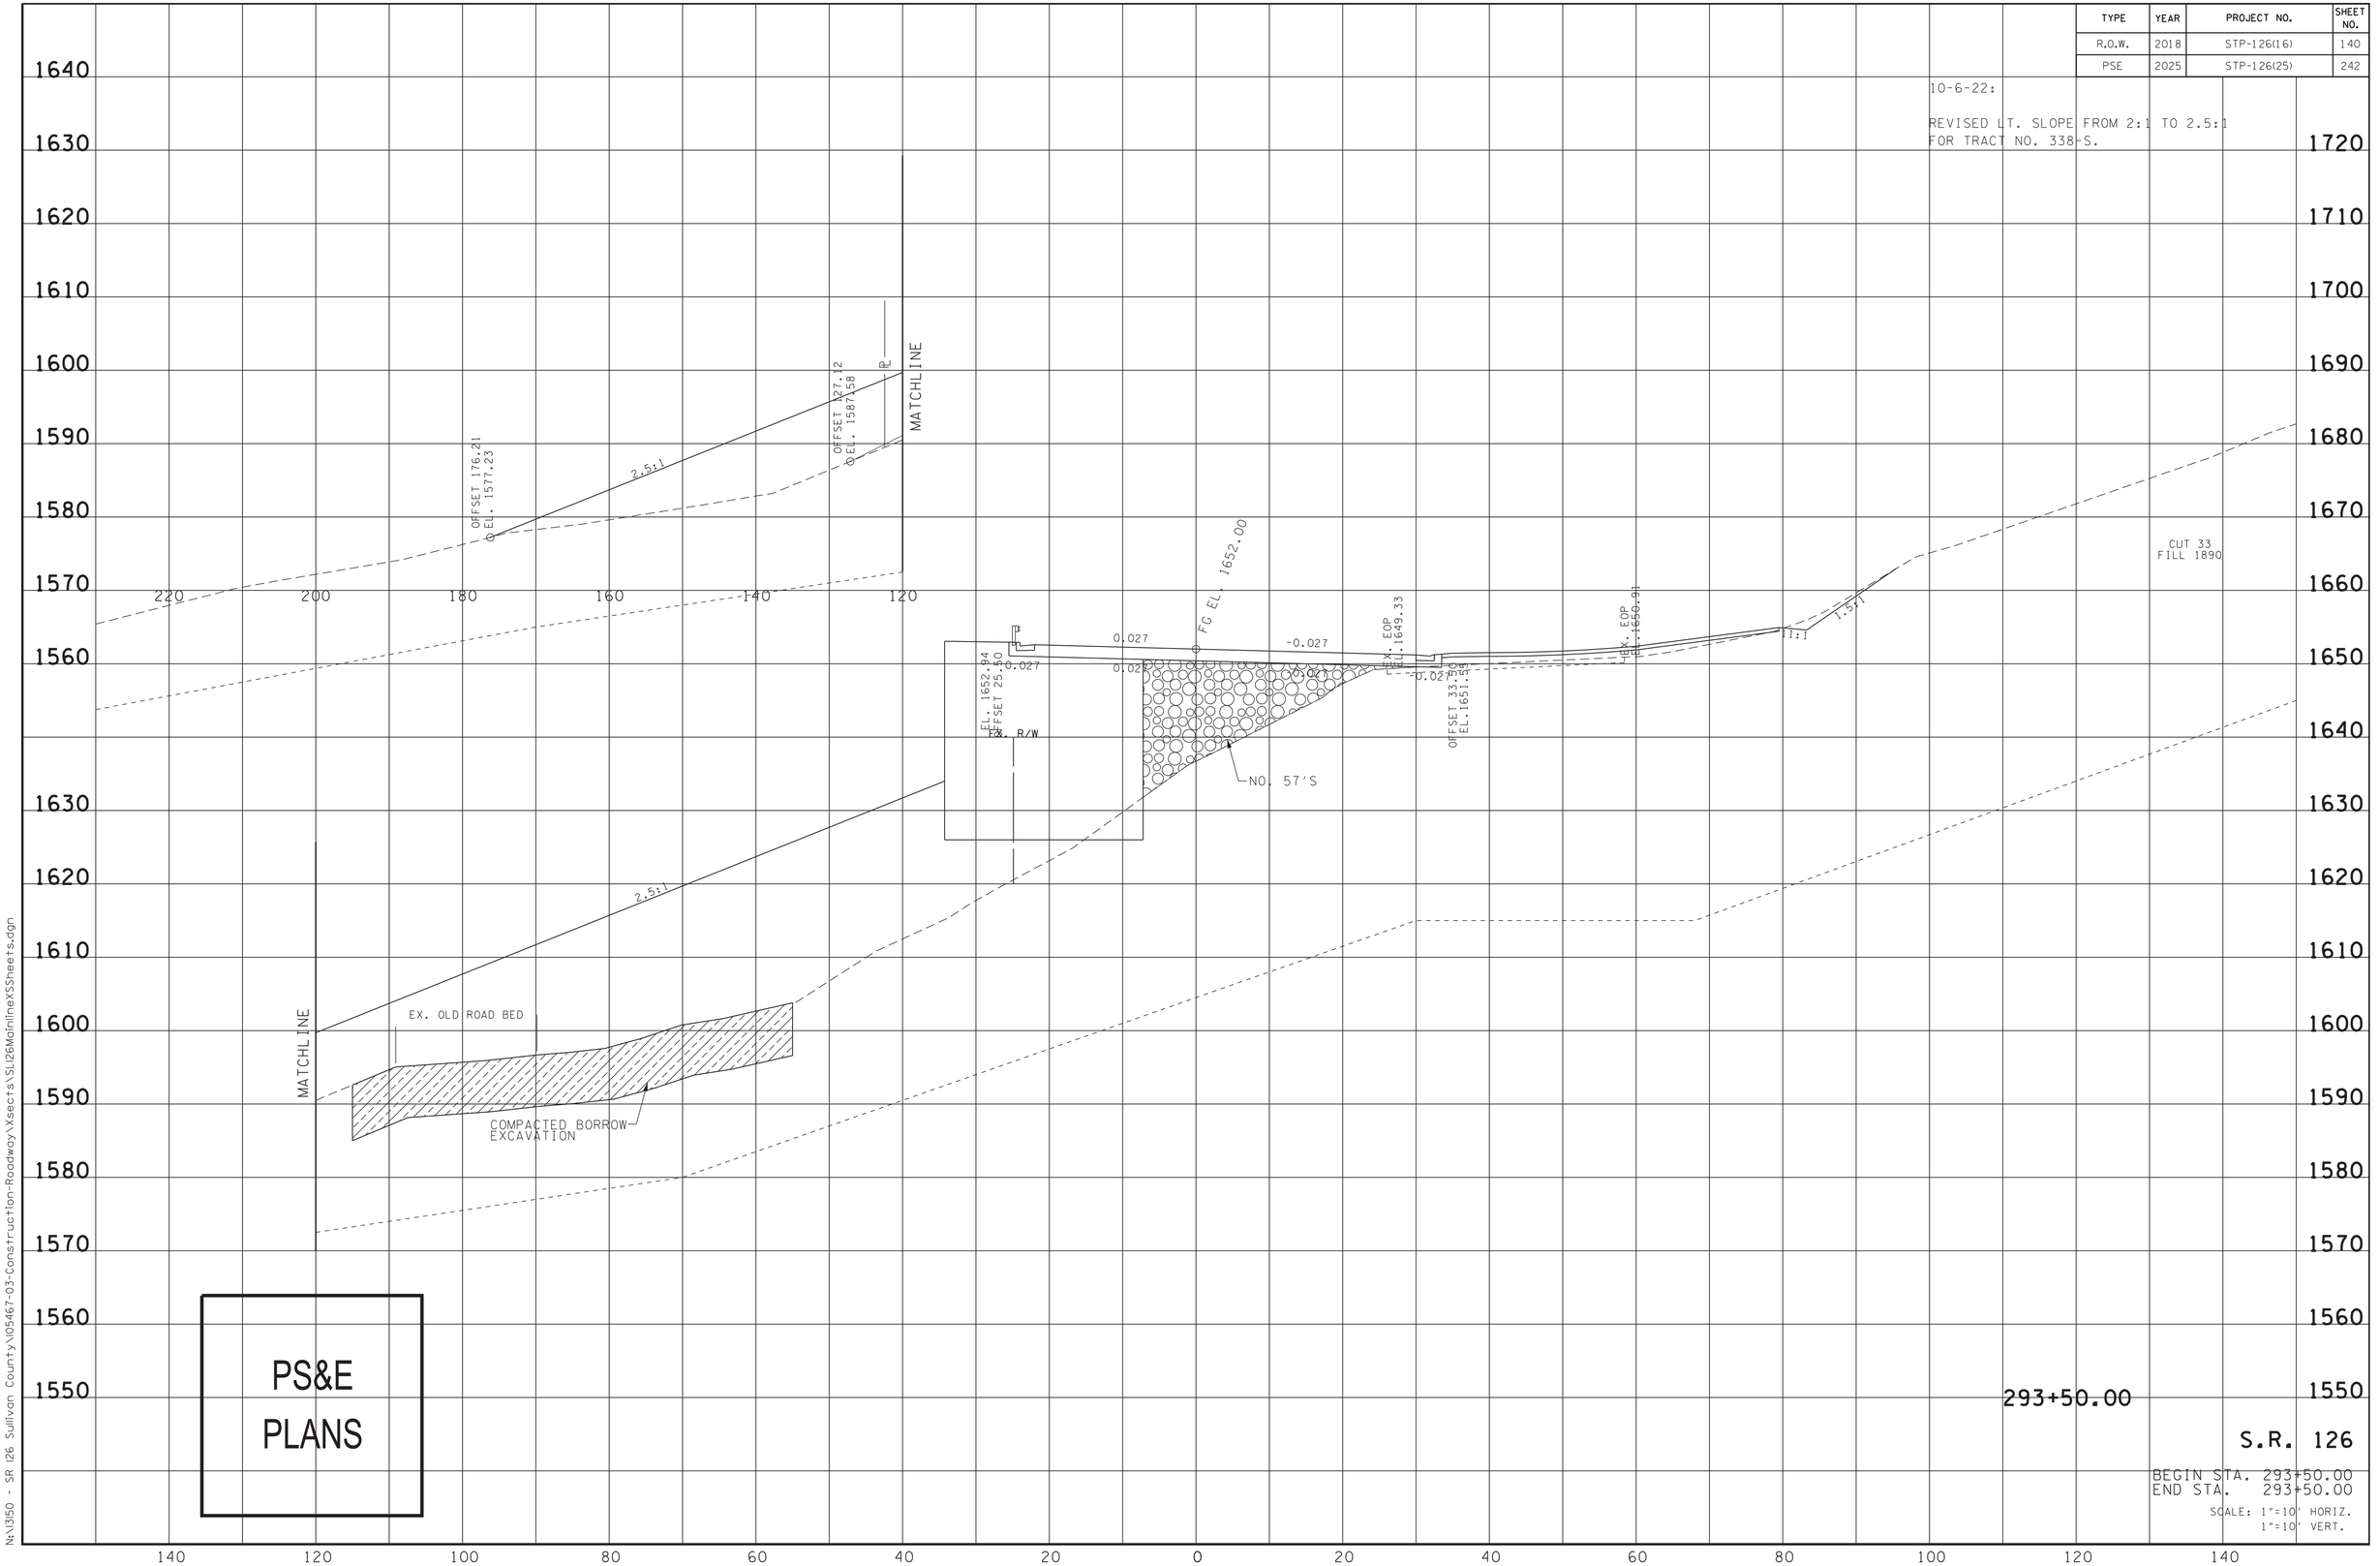
REVISED LT. SLOPE FROM 2:1 TO 2.5:1
FOR TRACT NO. 338-S.

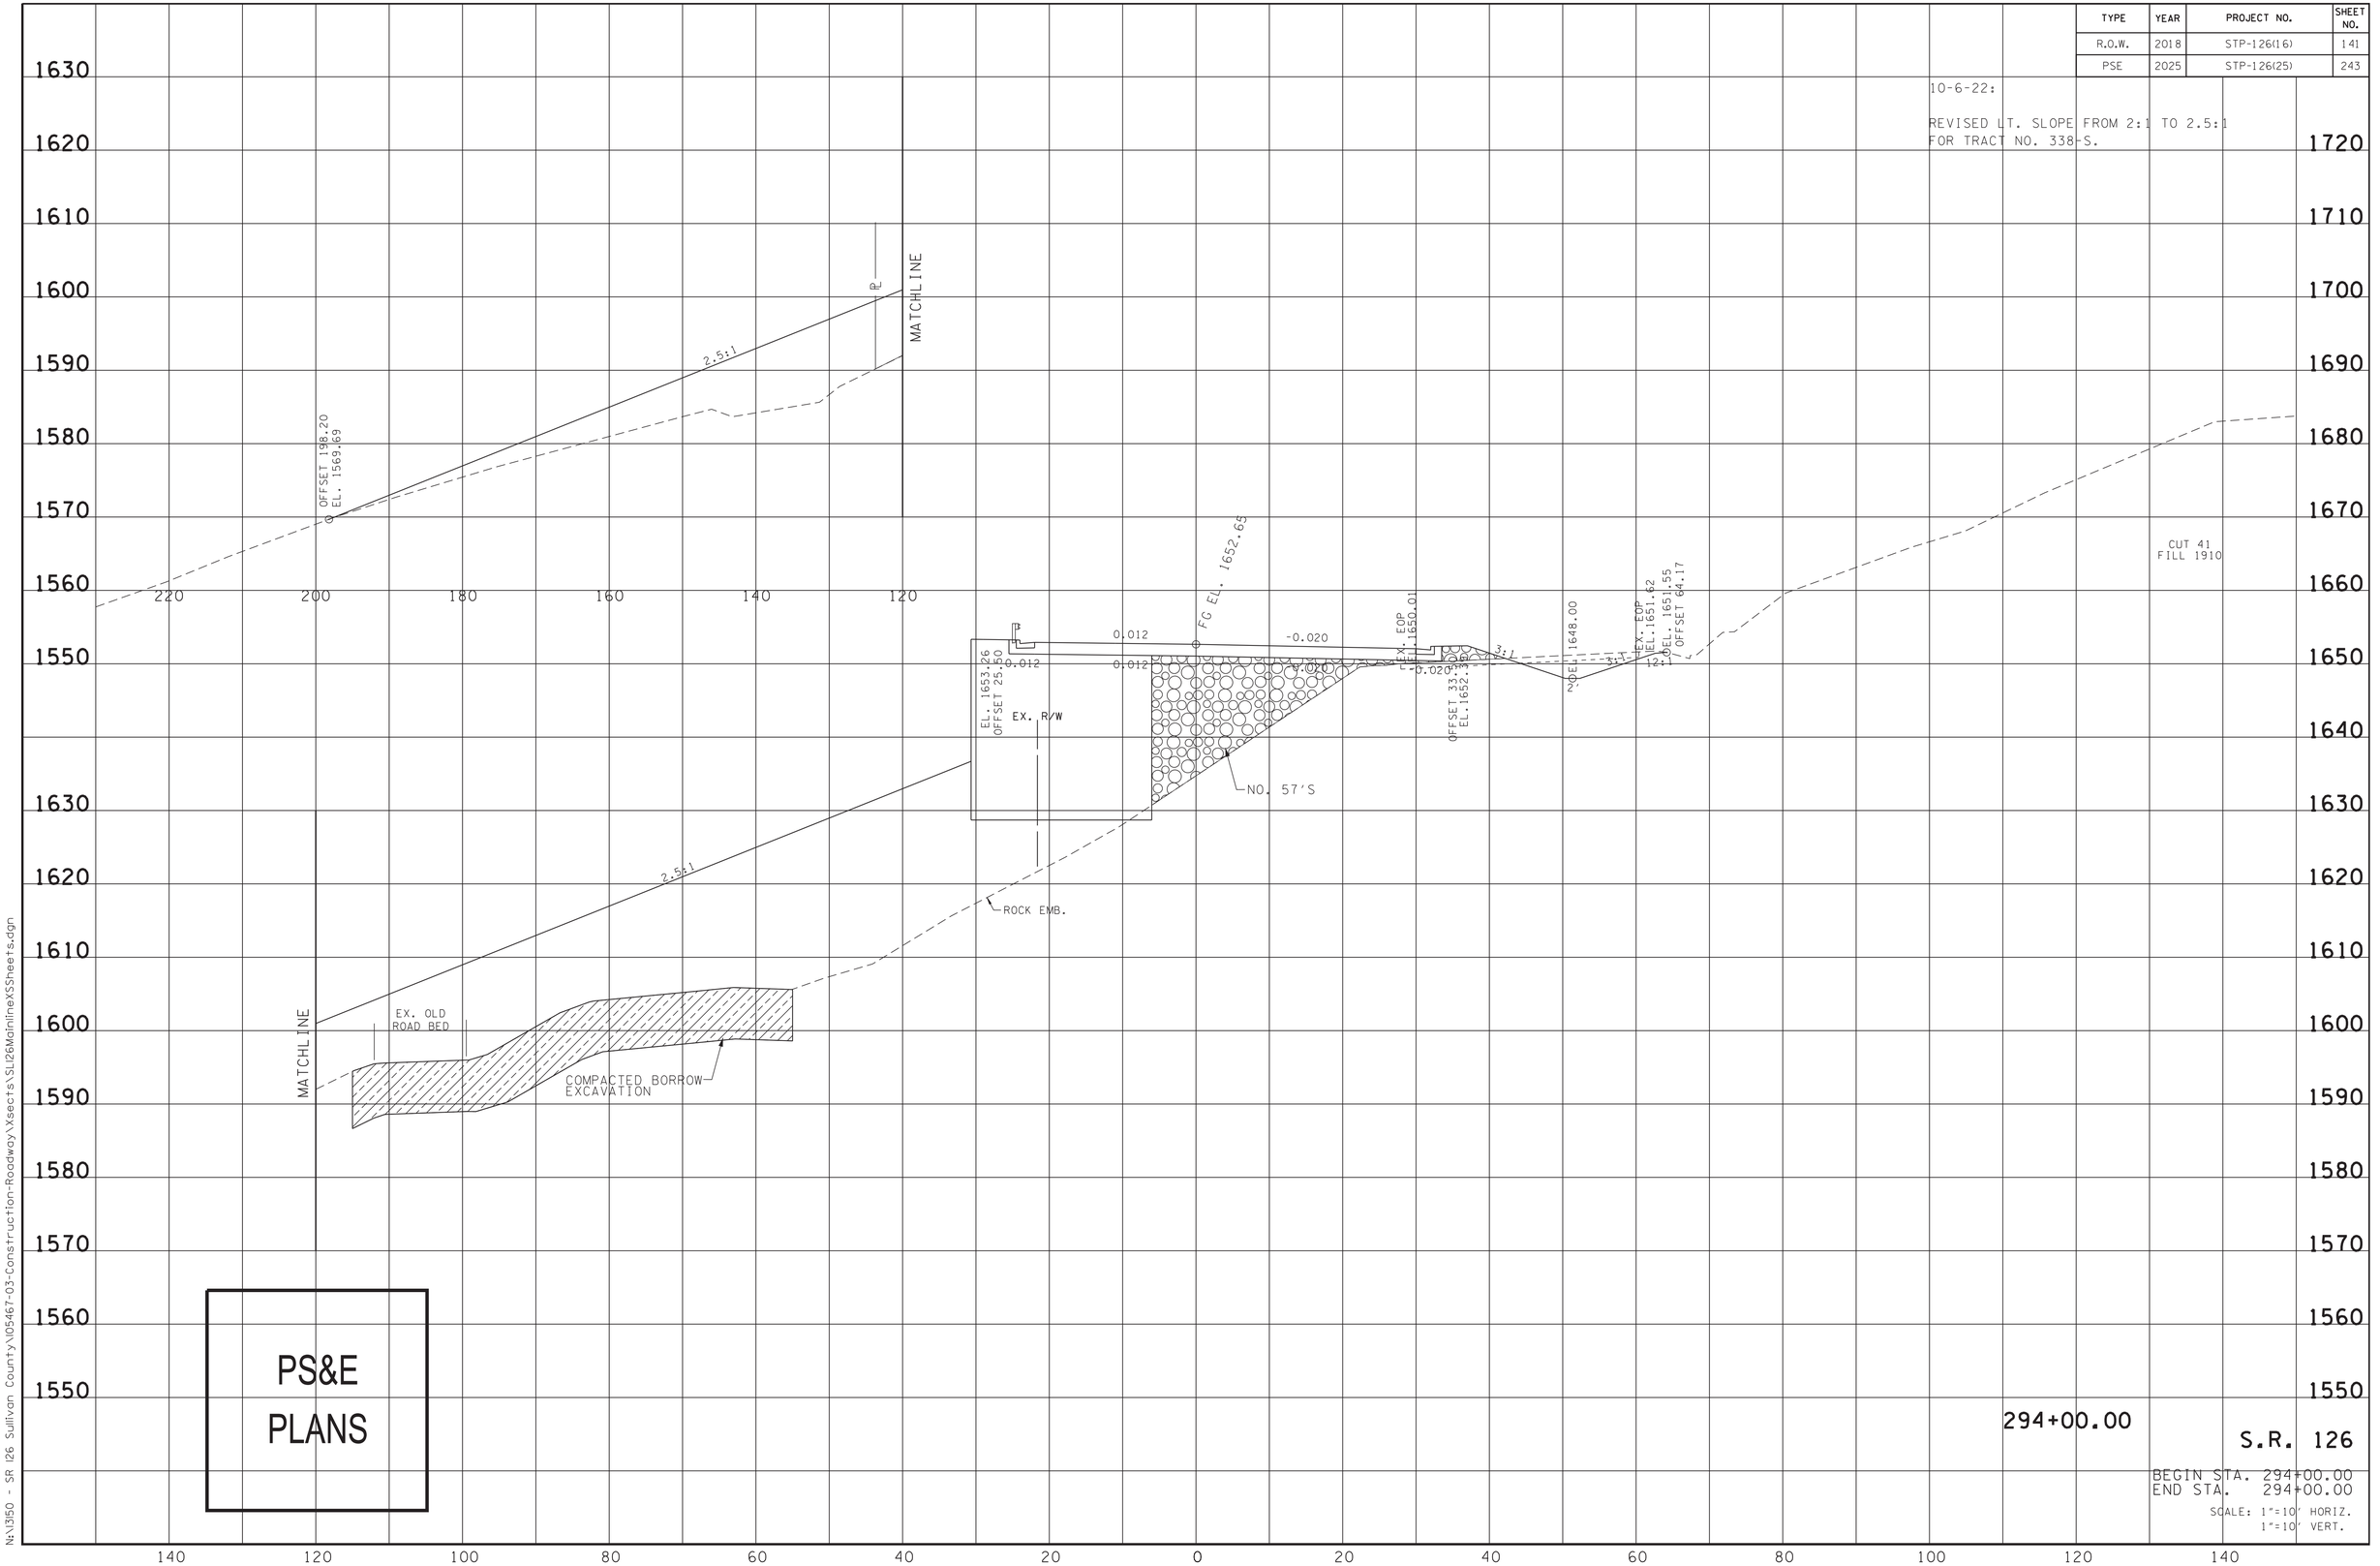
REVISED LT. SLOPE FROM 2:1 TO 2.5:1
FOR TRACT NO. 338-S.

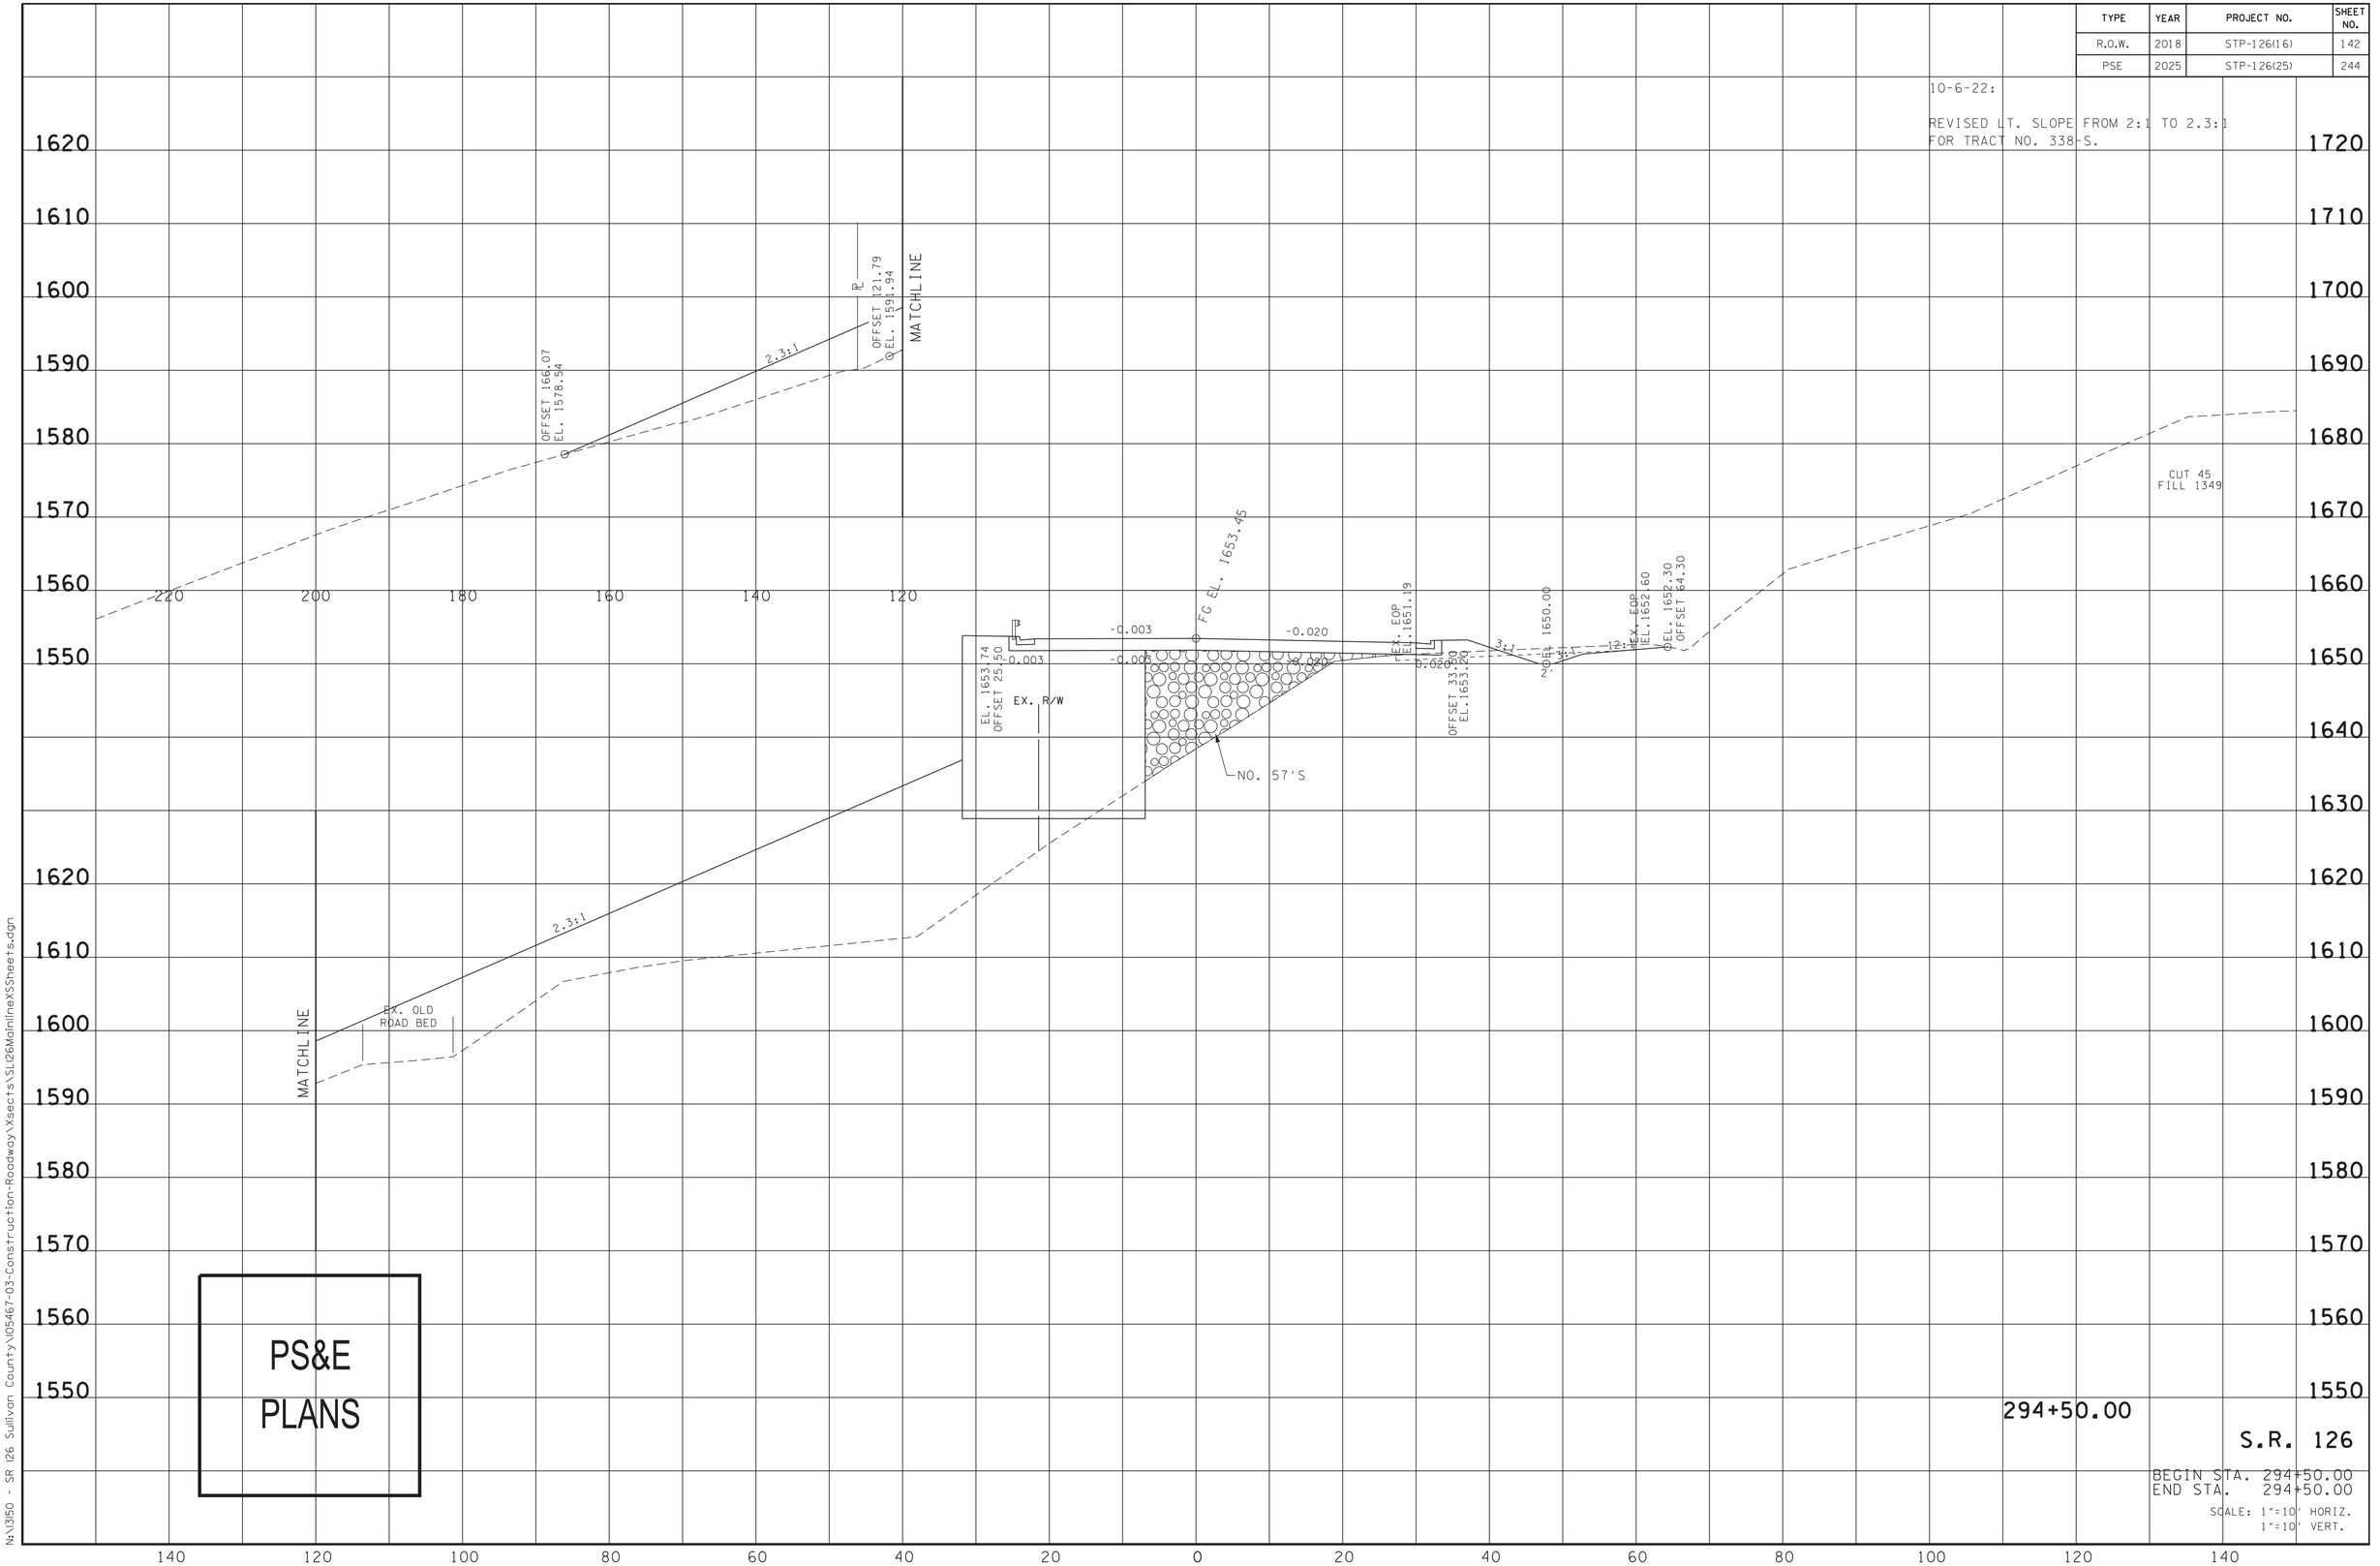
REVISED LT. SLOPE FROM 2:1 TO 2.3:1
FOR TRACT NO. 338-S.
